**STAFF REPORT
 PLANNING MANAGER DECISION**

DATE: July 15, 2014
 FILE NO.: DR-14-03
 REQUEST: Request for Class I Design Review at 19121 Willamette Drive
 PLANNER: Tom Soppe, Associate Planner

**APPLICATION FOR CLASS I DESIGN REVIEW
ROBINWOOD SHOPPING CENTER
JUNE 2014**

① SITE PLAN
1" = 30'-0"

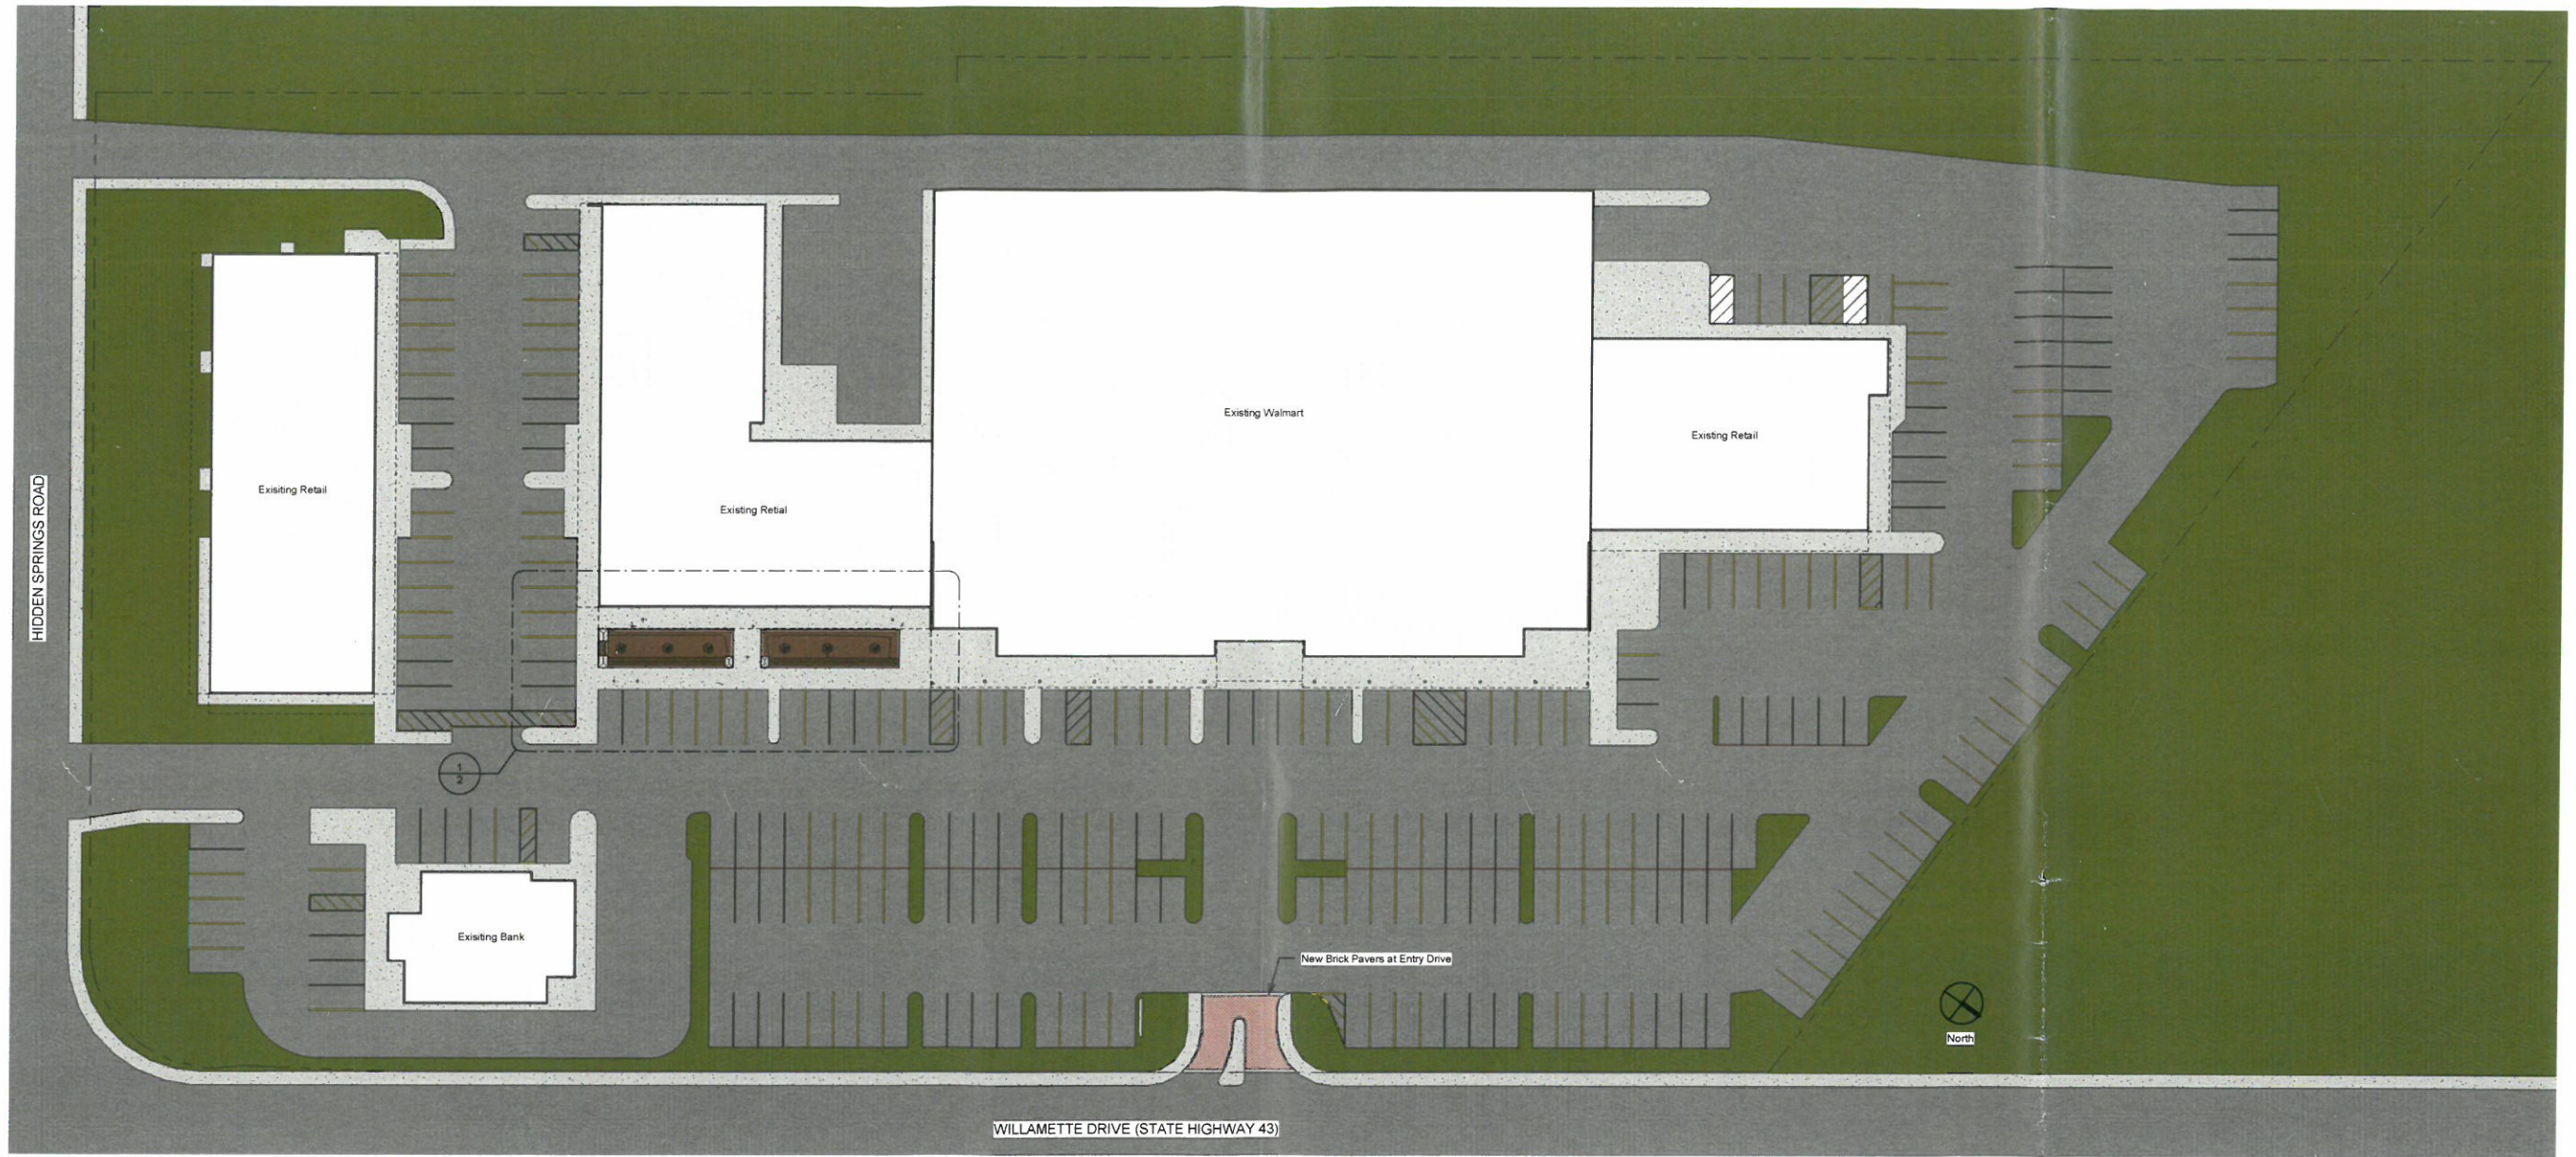
1. Site Plan, and Structural Connection to the Building. The project shall conform to the submitted exhibits, sheets 1 through 4, dated June 16, 2014 on pages 24-28 of Exhibit PD-4, with the following exceptions:
 - A) The applicant shall submit new plans that show the placement of architecturally compatible beams that make structural connections to the proposed walls to the building at the south end (west end of clock tower wall to main building) and the north end (band wall connection to main building).
 - B) The resubmitted plans shall meet the Building Official's approval for what constitutes a structural connection.
2. Signage. All signs proposed to be on the band wall shall be removed from the main building wall.
